IMPROVEM ANCHORAGE F IH FLOOR TENA 923 W 11TH AVE, AN

ADDENDUM #1 - 2.13.2

Checked By: JAM,XPT .9.2020 BID SET L9049 ELECTRICAL REMODEL SHEET NO:

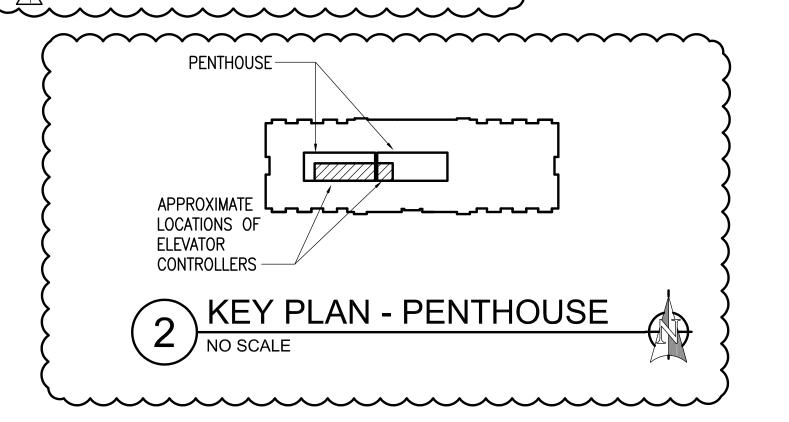
- 1. NEW PANEL BOARD AT EXISTING LOCATION. CONNECT EXISTING FEEDER AND BRANCH CIRCUITS. ALL RECEPTACLE CIRCUITS IN BEDROOMS SHALL BE CONNECTED TO AFCI CIRCUIT BREAKERS. SEE SHEET E3.1.

- 2. PROVIDE CONNECTION TO EXISTING NURSE CALL/WANDER MANAGEMENT SYSTEM. PROVIDE NEW ANTENNAS AND CONTROL UNIT ON UNIT SIDE, MAGNETIC LOCK (ONE EACH LEAF FOR DOUBLE DOORS), AND DISARM PUSHBUTTON ON NON-UNIT SIDE FOR WANDER MANAGEMENT.

- 3. NEW MAGNETIC DOOR HOLD. PROVIDE POWER SUPPLY OR 120V CIRCUIT CONNECTION. PROVIDE CONNECTION TO FIRE ALARM SYSTEM TO RELEASE UPON GENERAL ALARM.
- 4. PROVIDE (5) DOOR HOLDER ZONES AS SHOWN. SMOKE PARTITIONS SHALL BE CONTROLLED SEPARATELY FROM ADJACENT COMPARTMENTS SO THAT DOORS CAN BE RELEASED UPON ALARM IN EITHER COMPARTMENT.

- 5. PROVIDE CONNECTION TO NEW FIRE/SMOKE DAMPER CIRCUIT IN NEARBY TOILET ROOMS. FIRE/SMOKE DAMPERS IN VENTILATION SHAFTS ARE INSTALLED ON GRILLES AND AREA DETECTION SHALL SERVE AS THE ACTUATING DETECTORS.

- 6. ALL FIRE/SMOKE DAMPERS WITHIN A SMOKE COMPARTMENT SHALL BE CONTROLLED TOGETHER.
- 7. EXTEND CIRCUIT(S) SAVED FOR RE-USE AND CONNECT TO RELOCATED LIGHTS.
- 8. CEILING-MOUNTED PATIENT LIFT CHARGING RECEPTACLE. PROVIDE CONNECTION TO LOCAL RECEPTACLE CIRCUIT.
- 9. RE-INSTALL NURSE CALL/WANDER MANAGEMENT CONTROLLER IN LOCATION SHOWN. PROVIDE CONNECTION TO DEVICES AT NEW DOUBLE DOORS AND STAIRCASE DOOR.
- 10. PROVIDE SINGLE-PORT SURFACE TELECOM OUTLET FOR CONNECTION TO VIDEO SURVEILLANCE CAMERA (PROVIDED UNDER SEPARATE CONTRACT). PROVIDE CABLING TO BASEMENT SERVER ROOM. FOR BIDDING PURPOSES, ASSUME 200' OF CABLING AND THAT THERE IS AN EXISTING PATHWAY. TERMINATE CABLING ON EXISTING PATCH PANEL.
- 11. PROVIDE DOOR CONTACT AND CHIME KIT FOR MONITORING OUTBOUND LEAF OF THIS SET OF DOORS. WIRELESS CHIME SHALL BE INSTALLED AT NURSE'S STATION. STI #360 OR EQUAL.

12. JUNCTION BOX FOR AUTOMATIC DOOR OPERATOR. ACTUATORS SHALL BE INSTALLED ON BOTH SIDES OF ONE LEAF. PROVIDE CONNECTION FROM ACTUATORS TO OPERATOR. CONNECT TO CIRCUIT #4E-34 AS SHOWN ON THE PANEL SCHEDULE. COORDINATE WITH DIV 8 FOR CONNECTION REQUIREMENTS.

13. PROVIDE CONNECTION TO ELEVATOR CONTROLLER LOCATED IN THE 7TH FLOOR PENTHOUSE. REFER TO KEY PLAN 2/E2.1 FOR LOCATION OF PENTHOUSE. ELEVATOR IS BY OTIS. COORDINATE WITH OTIS FOR CONNECTION POINT AND CABLING TYPE TO THE CONTROLLER. THE INTENT IS TO HOLD THE CAR DOORS OPEN WHEN WANDER MANAGEMENT IS ACTIVE, SIMILAR TO THE NORTH TOWER.

14. PROVIDE CONNECTION TO EXISTING NURSE CALL/WANDER MANAGEMENT SYSTEM. PROVIDE NEW ANTENNAS AND A CONTROL UNIT FOR EACH CAR.
